FIRE SAFETY INSPECTION REPORT

SHOMAHAR SWEATERS LTD.
A-99/1, BOKTERPUR, KALIAKOIR, GAZIPUR

ACCORD
on Fire and Building Safety in Bangladesh

May 28, 2014

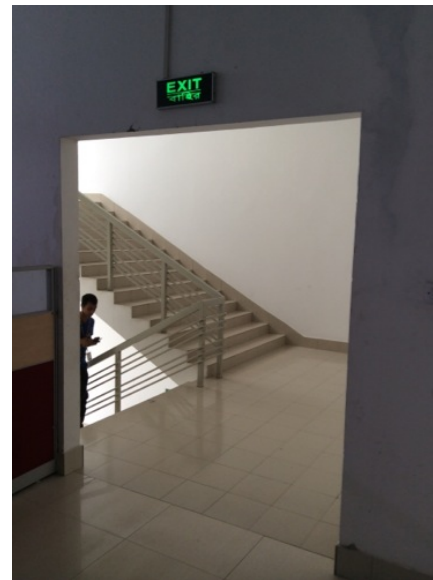
No.	Category	Finding	Recommendation	Remediation Timeframe
F-1	Fire Rated Construction	The boiler, generator and transformer rooms are not separated by fire-rated construction (openings, non-rated doors, penetrations). The rooms are open to egress path.	Separate the boiler, generator and transformer rooms by a minimum 2-hr fire-rated construction. Seal and or protected all openings to maintain the required fire separations	Within 3 months
